**PROPOSED HOUSING DEVELOPMENT,
MOANBAUN, MOUNTRATH, CO. LAOIS**

Road Safety Audit Stage 1/2

Hayes Higgins Partnership

Project Title	Proposed Housing Development, Moanbaun, Mountrath, Co. Laois
Project No.	24005-01
Client	Hayes Higgins Partnership (HHP)
Document Title	Road Safety Audit Stage 1/2
Document No.	24005-01-001

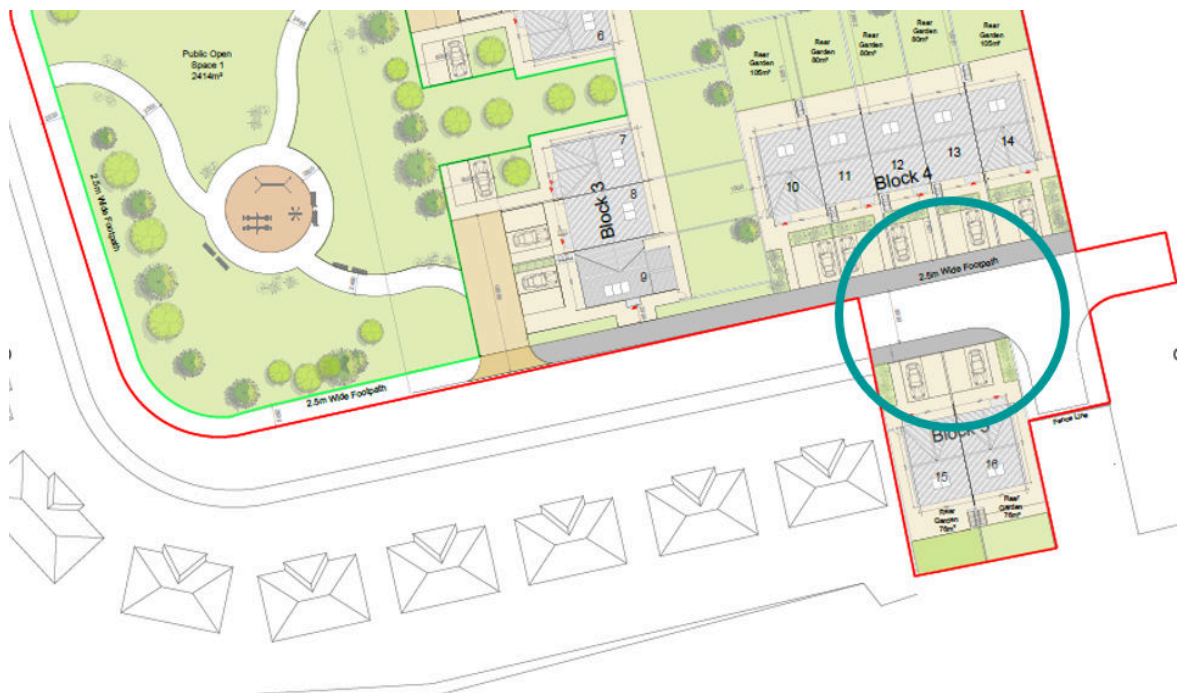
The section of Moanbaun Close – the road section that extends to Derrymore Gardens – is relative long and straight. Traffic speed could be relatively high. The gate to Derrymore Gardens was closed on the day of the site visit but it is assumed that it could be open to traffic at some time. Road safety risk could be increased by high vehicle speeds.

Provide traffic calming on this section of road to ensure that motor vehicles travel at an adequately slow speed.

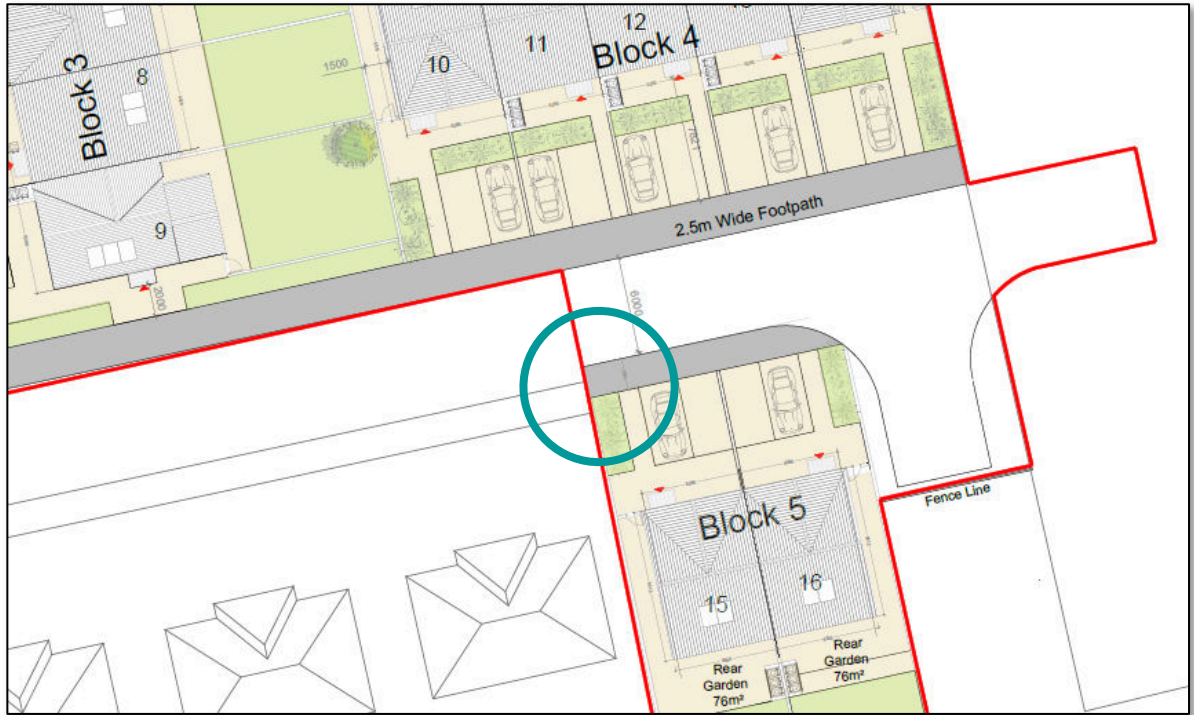
New tactile paving and dished footpaths have been placed at the access to Woodbrook. The drawing does not show that they are to be retained but it is assumed that they will.
